| <b>DOCKETED</b>         |   |
|-------------------------|---|
| <b>Document Title:</b>  | Kelly Rogers Comments - National Hydropower Association<br>Comments to Draft 2024 IEPR Update |

**National Hydropower Association Comments to Draft 2024 IEPR Update**

**Subject: Comments on the Draft 2024 IEPR Update**

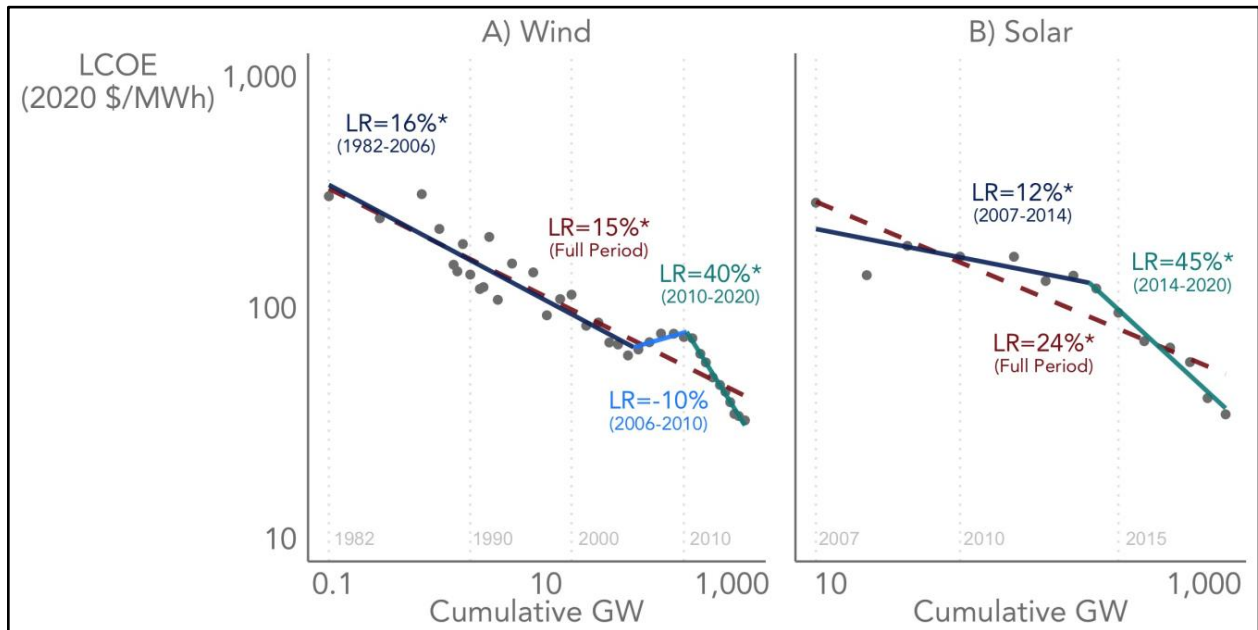
We acknowledge that cost reductions, as pointed out on page 49, would be a major factor contributing to the increased use of wave and tidal energy in California. The first two sentences of this section read:

The convergence of technology types and increased capacity installation should directly lead to cost reductions. However, there are additional factors regarding cost that should also be considered.

First, the energy density of the waves off California’s coast is around 20 times higher, on average, than the energy density of other renewables like wind and solar. Thus, the space and material required to reach the same level of installed capacity is significantly lower. This is also a key driver of the conclusion by the [Intergovernmental Panel on Climate Change \(IPCC\)](#) that marine energy has the lowest lifecycle emissions of any renewable energy source. If wave energy reaches the same cumulative manufacturing capacity as wind and solar, the costs may be significantly lower. It is critical that we not directly compare the costs of different technologies at different levels of cumulative manufacturing volume.

Second, LCOE may be the primary cost metric that project developers consider for individual projects, but it is not necessarily the best cost metric to look at when considering the interest of California ratepayers. Instead, we should look at the cost of the entire energy system. Because of their consistency relative to wind and solar, integrating wave and tidal energy into California’s generation mix may reduce costs for ratepayers even if individual project LCOE figures are higher than those for wind and/or solar.

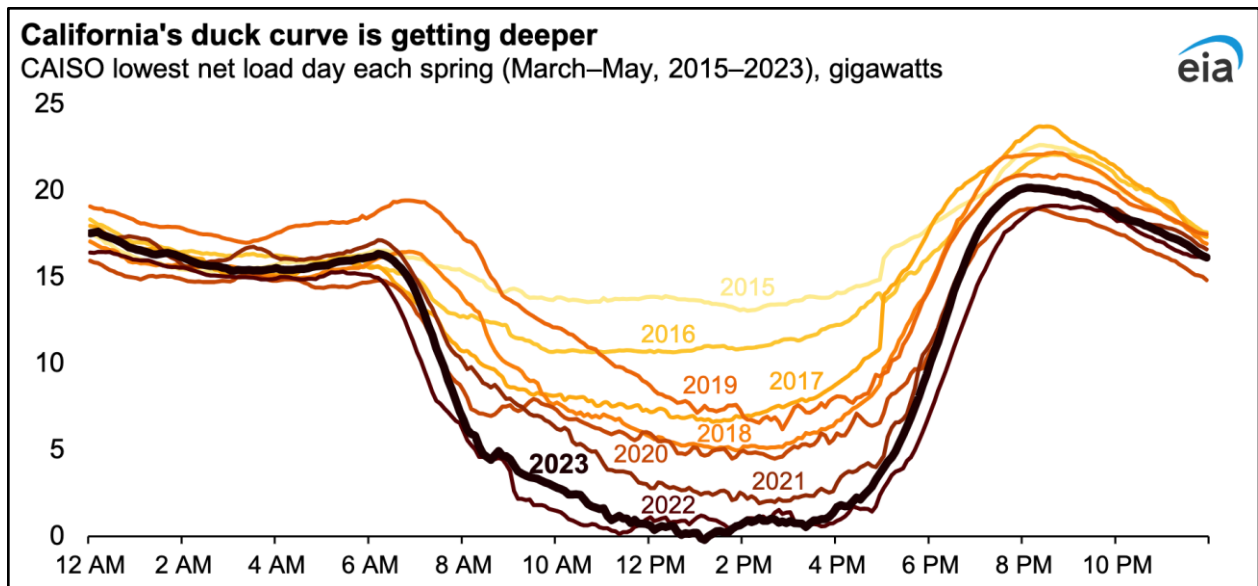
We recommend highlighting the challenges posed by California's [increased use of solar and wind in California](#) be added as a key factor that could drive demand for wave and tidal energy in the state. In our April submission, we included the following explanation:

*“However, the solar power resource is strongest in the middle of the day when demand is relatively low, and the availability of the resource drops significantly as energy demand increases in the evening. California’s growing reliance upon solar power means that dispatchable power plants (like coal, natural gas, and nuclear) must be ramped up more and more aggressively during the evenings in order to meet demand. This problem can be shown by the ‘Duck Curve,’ the plot of California’s net load (demand remaining after subtracting variable energy generation) throughout the day, which resembles a duck.”*

By addressing these challenges, wave and tidal energy—known for their consistency and predictability—could play a pivotal role in balancing California's energy system and reducing the reliance on ramping non-renewable power sources.
